**Public Works Subcommittee
Meeting on 14 April 2010**

**List of issues requiring follow-up actions by the Administration
before the Finance Committee meeting on 30 April 2010**

The proposed part-upgrading of **13GB** is to provide a village resite area with supporting infrastructure at Ta Kwu Ling for reprovisioning of the existing Chuk Yuen Village. This is the first step of the project for the development of Liantang/Heung Yuen Wai Boundary Control Point (BCP) which will only proceed after the completion of the reprovisioning of the village to the resite area. In respect of the detailed design and construction of the BCP itself and the associated new connecting road, we will consult the relevant LegCo Panels and submit funding applications separately at a later date when we are ready to take forward the implementation of the project.

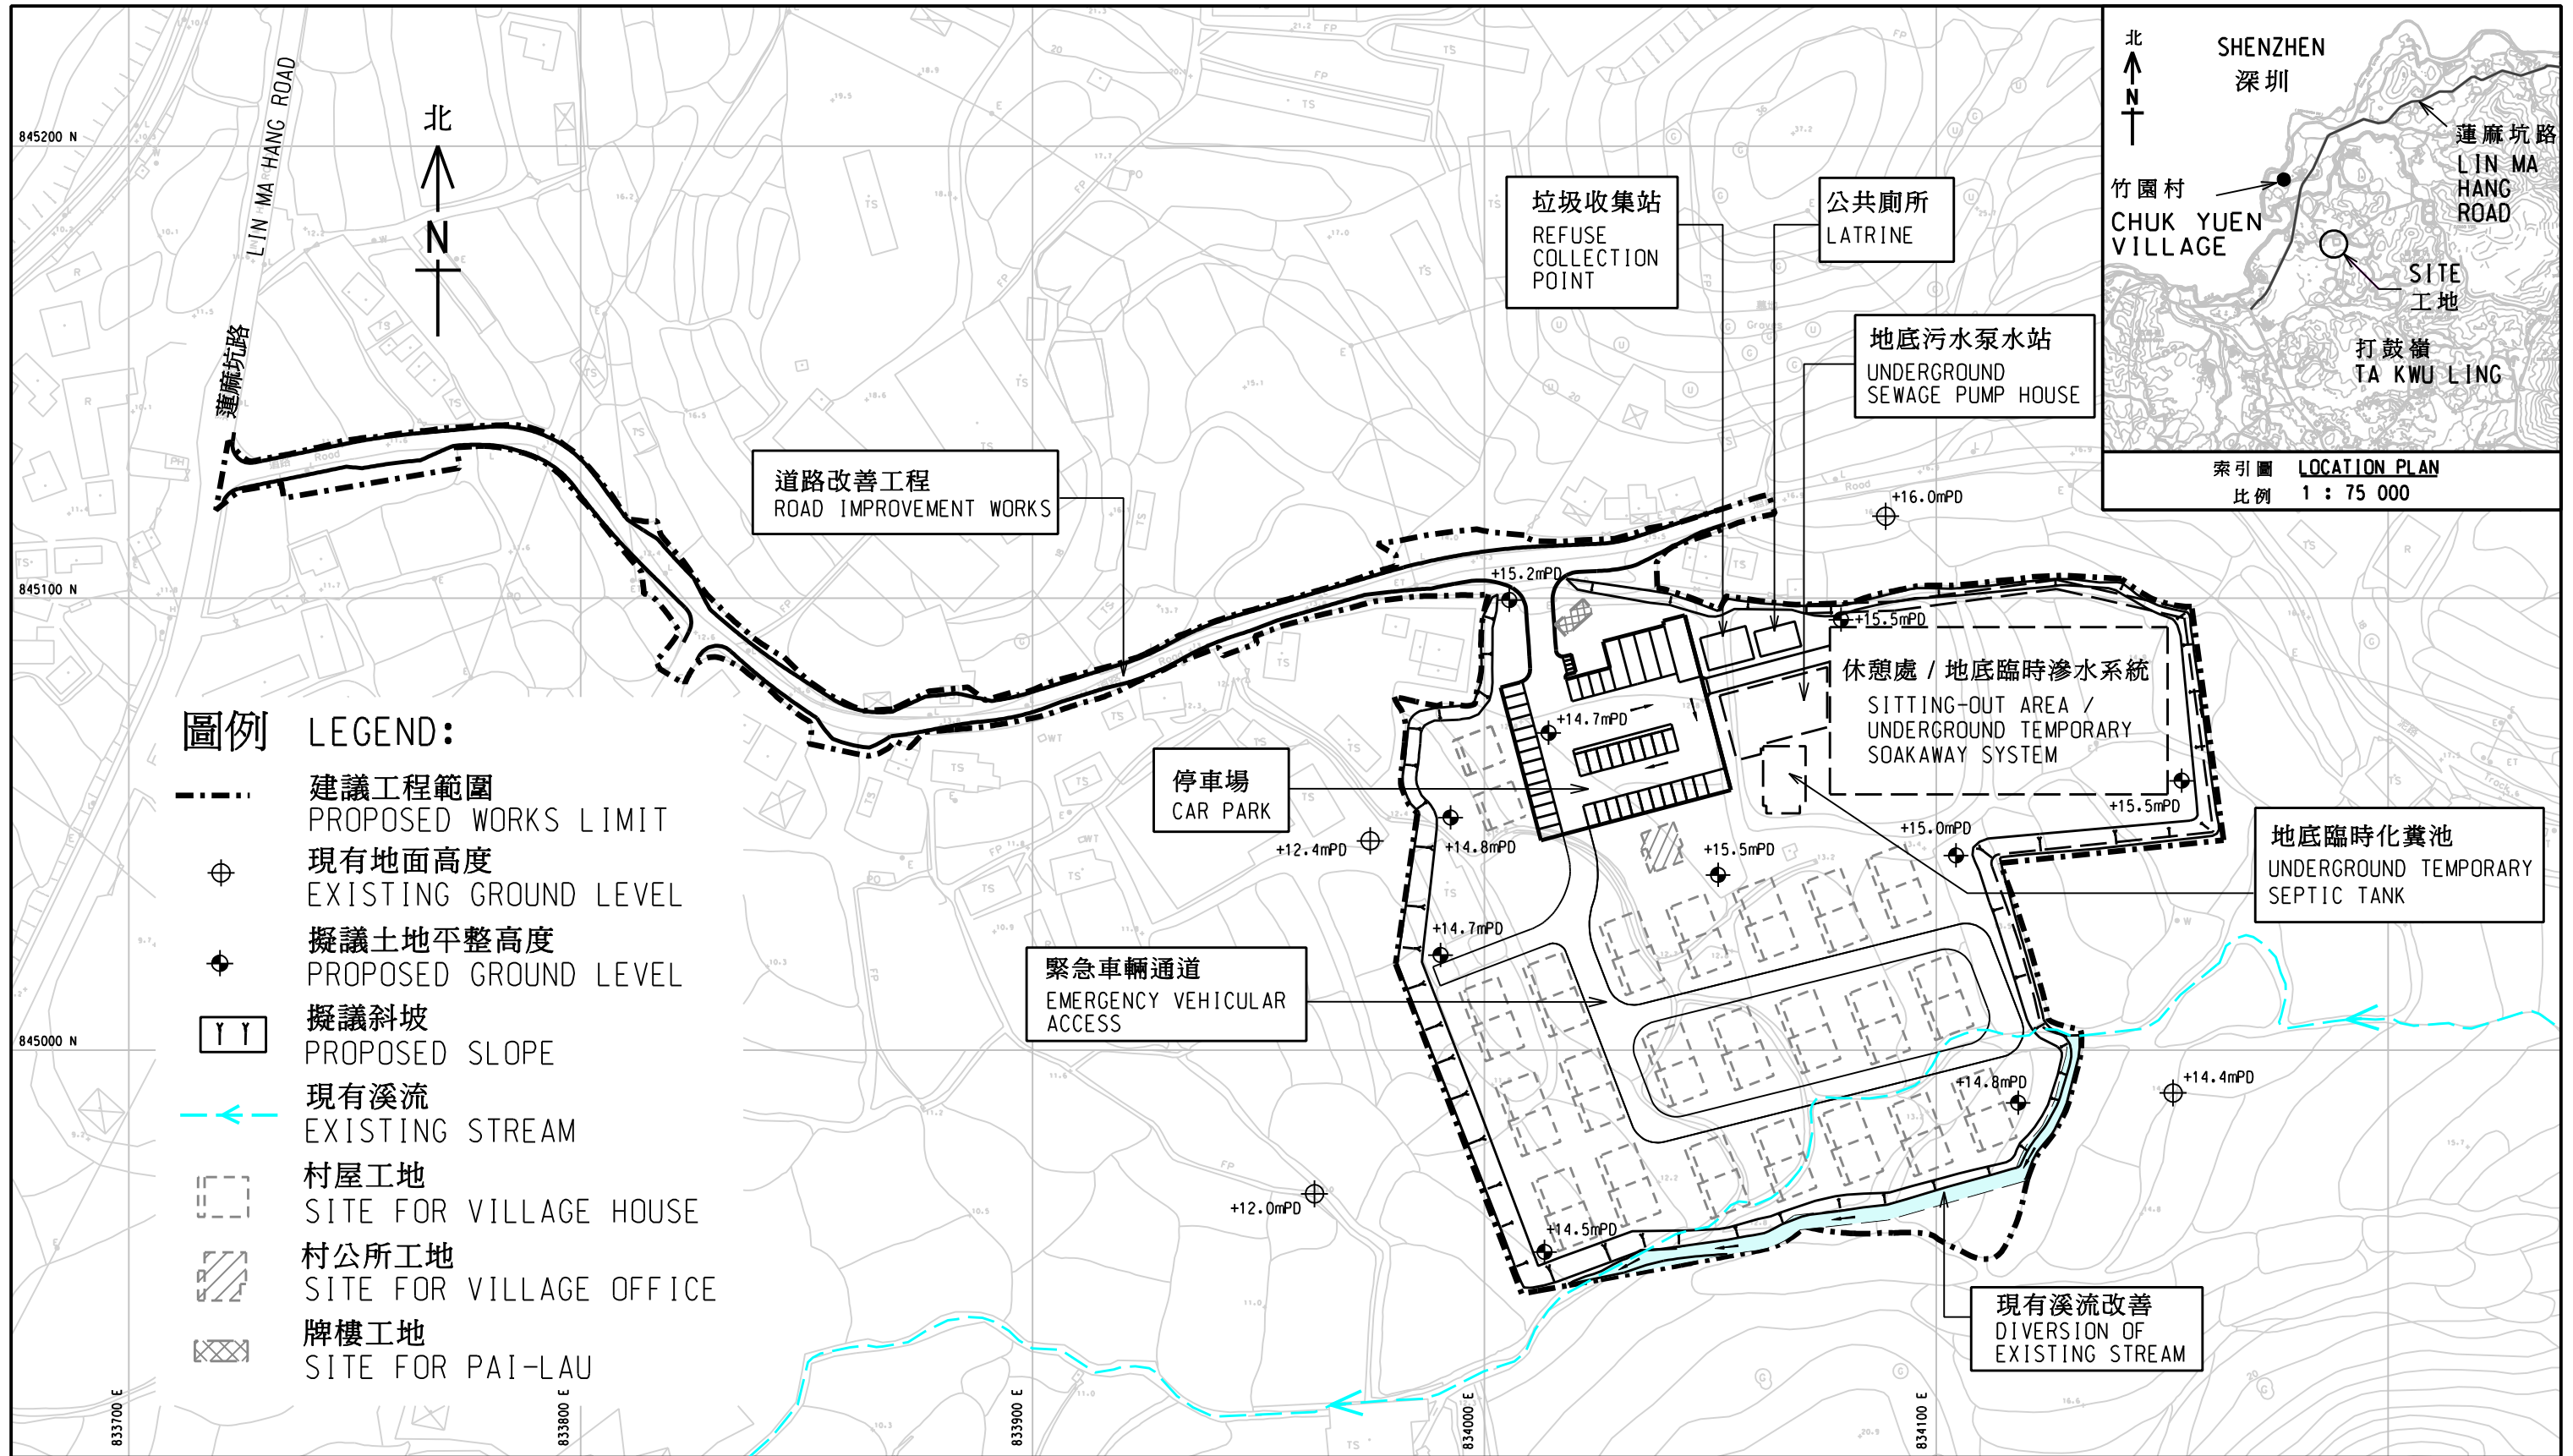
At the request of Prof Hon Patrick LAU, the Administration agreed to beef up the site plan at Enclosure 1 to PWSC(2010-11)2 to show the village houses and other public facilities at the resite area.

A plan showing the layout of the village houses and other public facilities is at **Enclosure 2**. We have had many rounds of discussions and exchanged views with the Chuk Yuen Village Removal Committee since 2009 in regard to the layout and ancillary facilities of the resite area, including site selection, site formation and stream diversion, disposition and orientation of the village houses. The layout was firmed up after discussion and agreement of the Village Removal Committee.
